# Evaluation of Physical Barriers – RCTC Office

Address: 4080 Lemon Street, Riverside, 92501

Evaluation Date: 07-23-2021

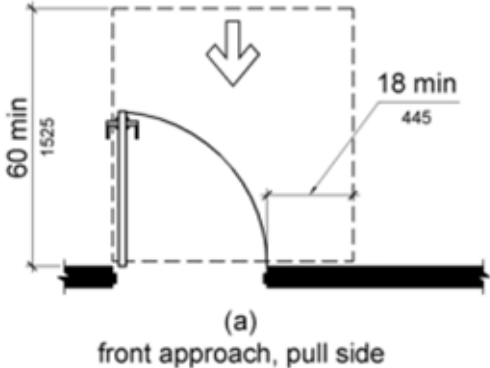
III. Exit door near the restroom leading to the exit stair is not compliant with requirements of “doors in series” per 404.2.6.  	Provide directional sign pointing to the alternate accessible exit route.  Or  Move the office side door and partitions to the inside to allow 48 inches clearance per figure 404.2.6.	 <p>(a)</p> <p><b>Figure 404.2.6 Doors in Series and Gates in Series</b></p> <p>404.2.6 Doors in Series and Gates in Series: The distance between two hinged or pivoted doors in series and gates in series shall be 48 inches (1220 mm) minimum plus the width of doors or gates swinging into the space.</p> <p>This is also a current building code requirement.</p> <p><b>1010.1.8 Door Arrangement</b></p> <p>Space between two doors in a series shall be 48 inches (1219 mm) minimum plus the width of a door swinging into the space. Doors in a series shall swing either in the same direction or away from the space between the doors.</p>

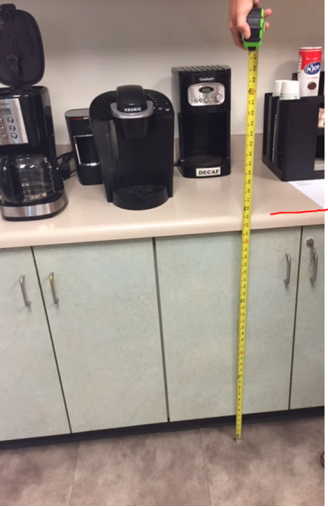
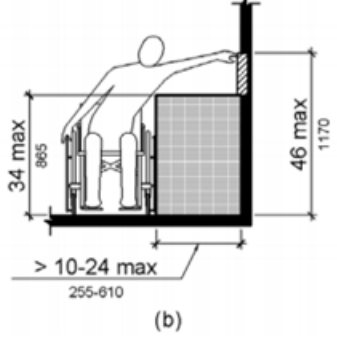
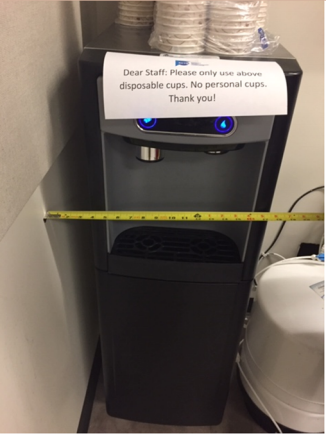
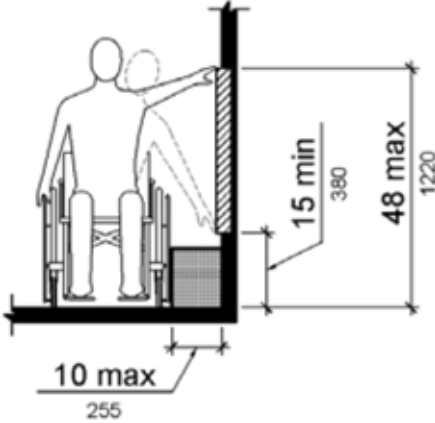
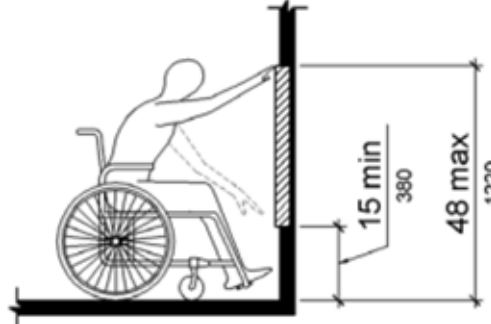
e. Controls for lighting and thermostats etc.		
i. Clear space to operate light switches in some conference rooms are blocked by chairs or tables.  	Relocate furniture to provide clear space at all operable parts.	 <b>Figure 305.3</b> <b>Clear Floor or Ground Space</b>  <b>309.2 Clear Floor Space.</b> A clear floor or ground space complying with 305 shall be provided.
